ADDENDUM NUMBER 5

SHOWER VENTILATION IMPROVEMENTS
RE-BID

Project No.: J042-10450

Contract 2: General Construction and Shower Ventilation

7 Typical Duct Barred Opening Connection Detail

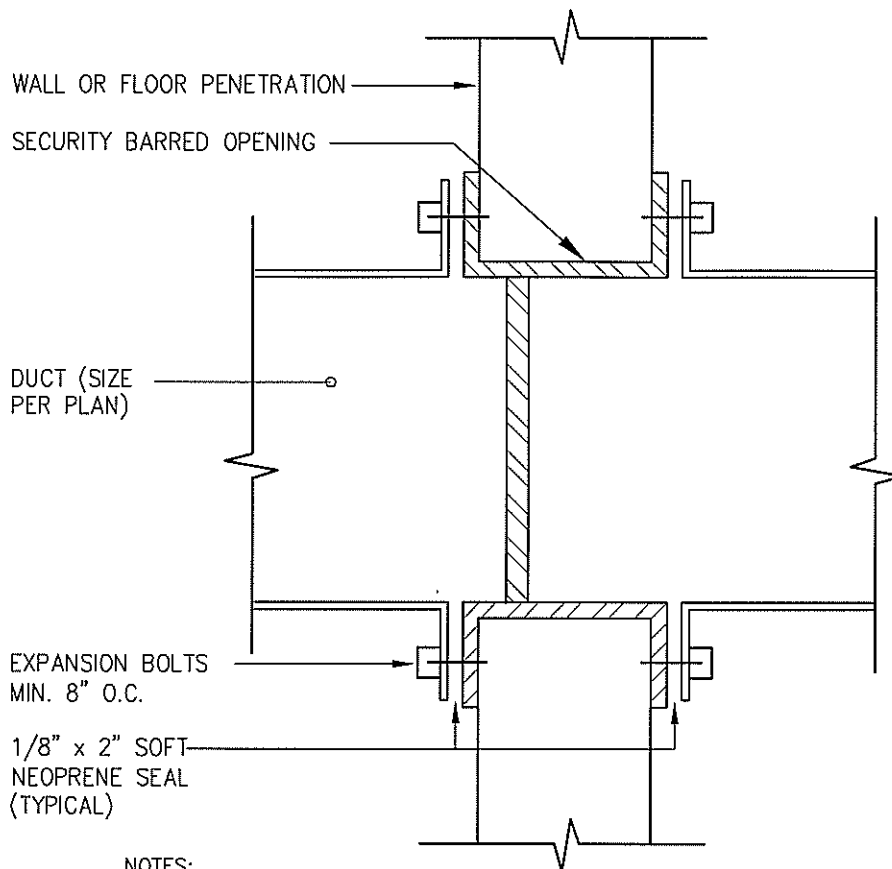
1. ADD Detail on sheet M-5 and number as Detail 7. See attached Drawing SD-1. Supplemental Drawing SD-1 is attached to and issued as part of this Addendum 5.

1. INSTALL MEDIUM SECURITY BARS AT OPENINGS. #8 REBAR LOCATED 6" ON CENTER VERTICALLY AND HORIZONTALLY. THE END REBAR TO BE EMBEDDED 8" ON EACH END.
2. BARS SHALL BE EPOXY COATED.
3. SEAL ALL DUCTS JOINTS WITH SILICONE SEALANTS.
